Accu- Vis Feasibility Evaluation

Proposed design: Feature Feasibility Evaluation

Linsear Guide

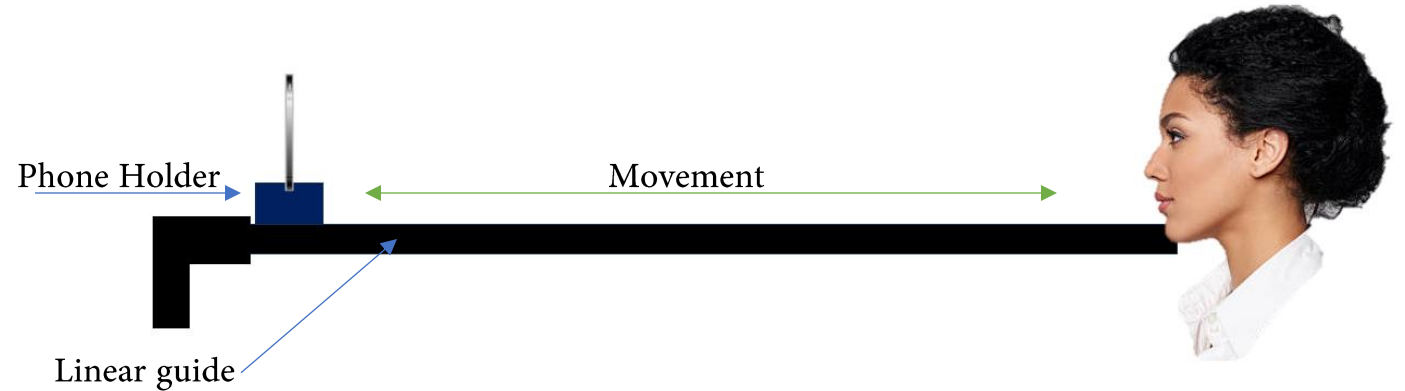
- Allows the phone holder to move **forward and backward**.
- Possible usage of motor either **Stepper or Servo**.
- May cause **heavier** mass due to motor's existence.

Pivot Connector

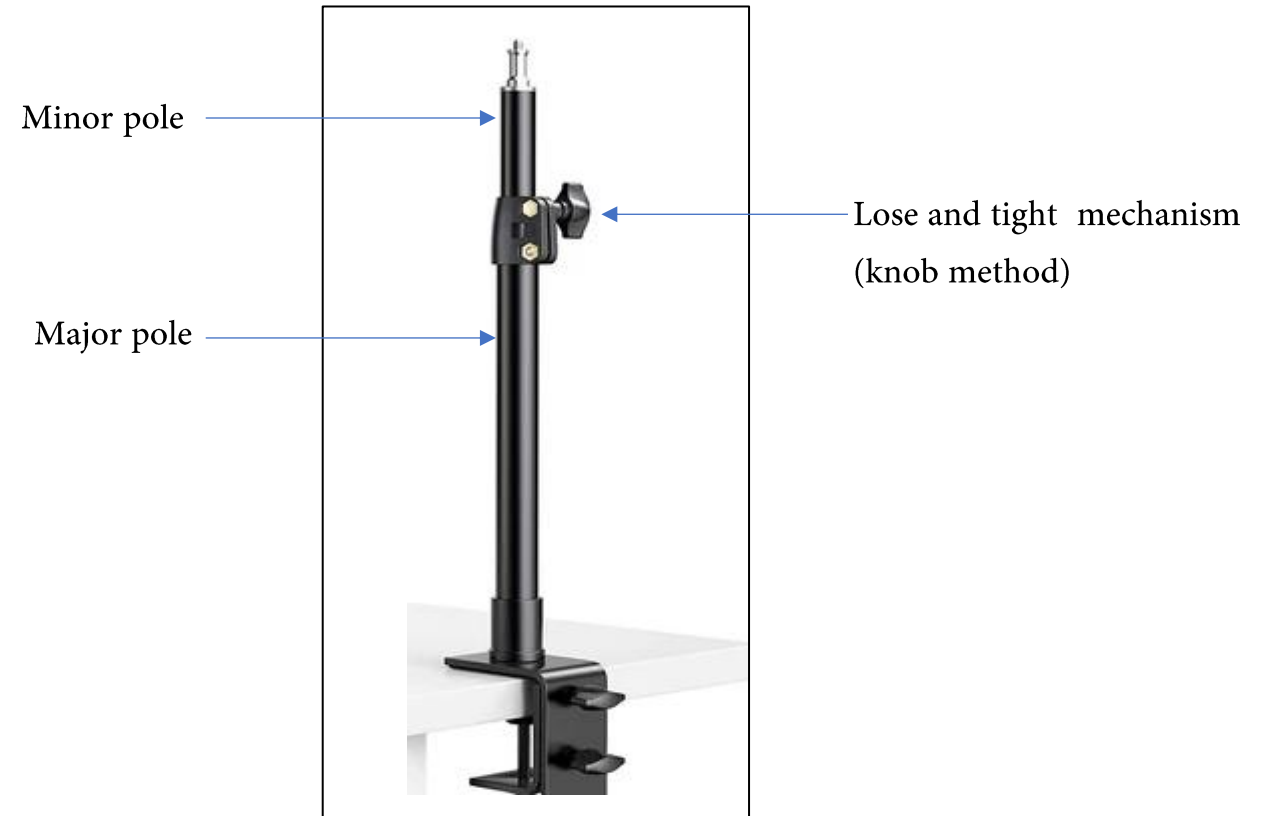
- This type of approach is **not practical and will not even work.**
- The design for this must be **through and through** the linear paths to adjust the height and length of the prototype.

Suggested approach

Chin Rest

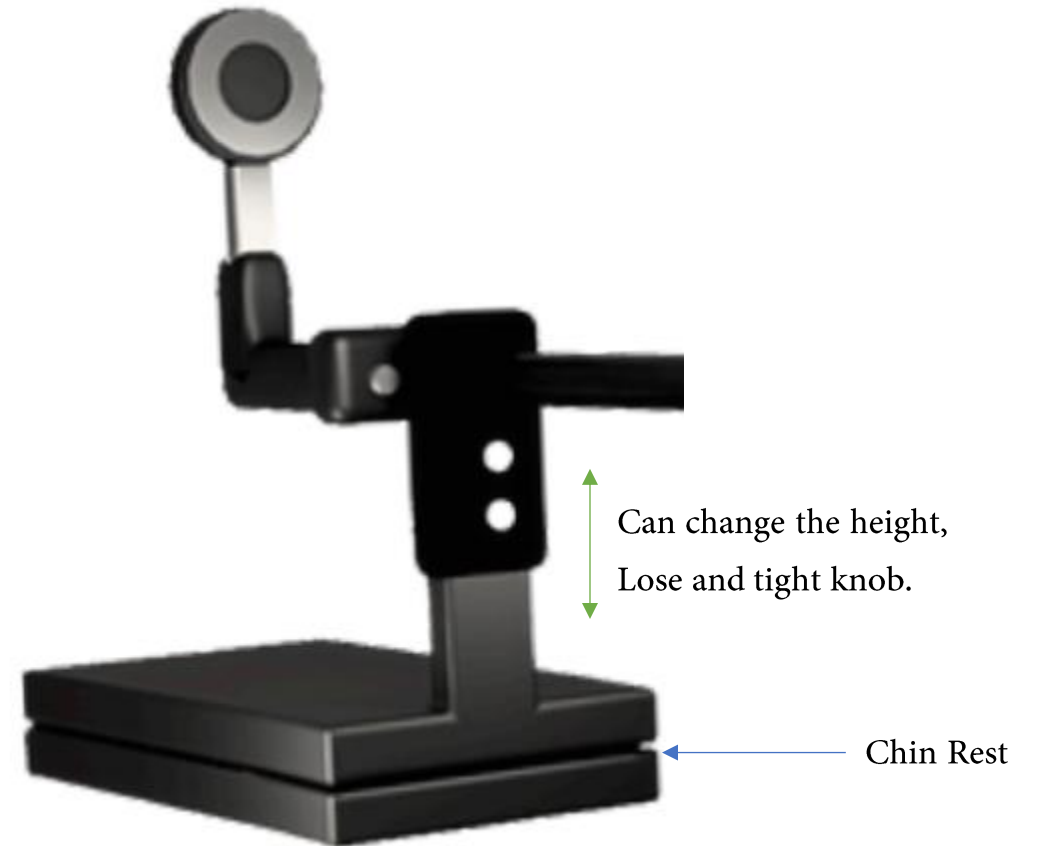
- Can create a design base on the **eye to chin distance** of each heads.
- Possible knob adjusted approach just like the idea on pivot connector.

Phone Holder

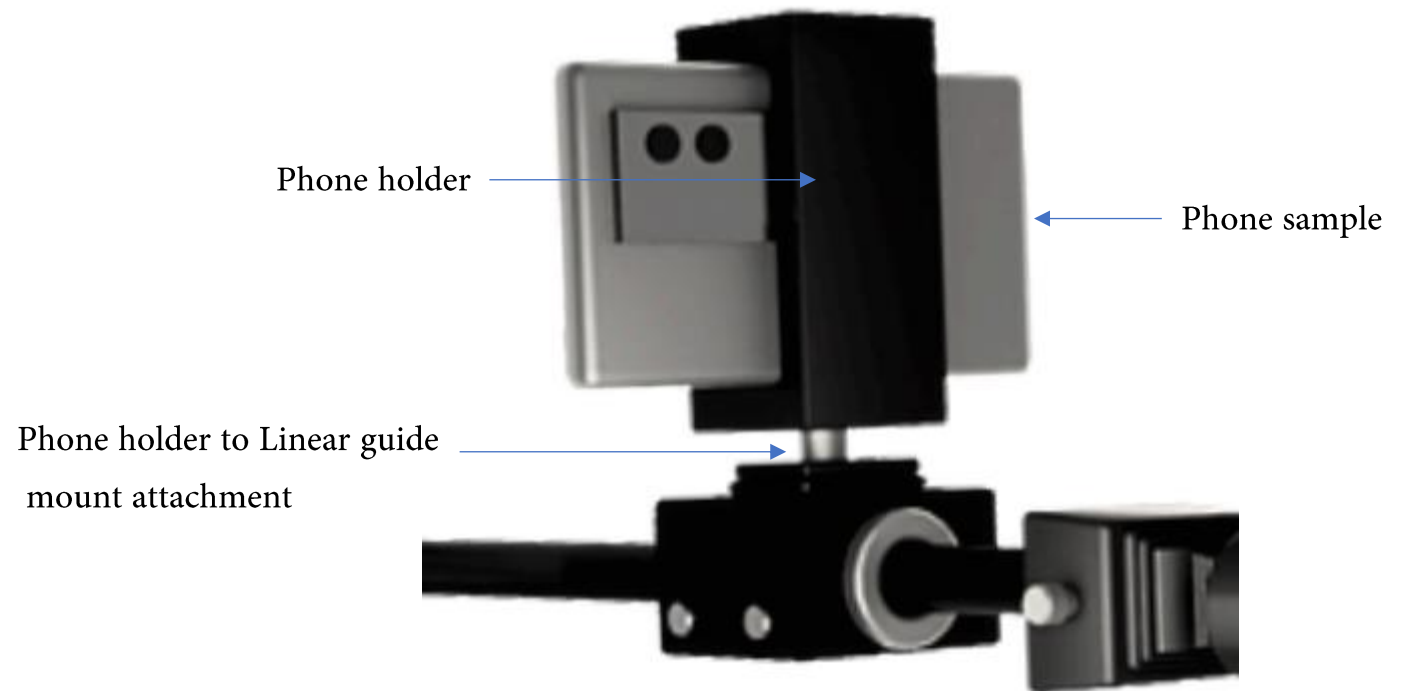
- Designed to hold the phone to be used in the test.
- Will be designed according to the attachments of the linear guide's design. (brand design specifications)
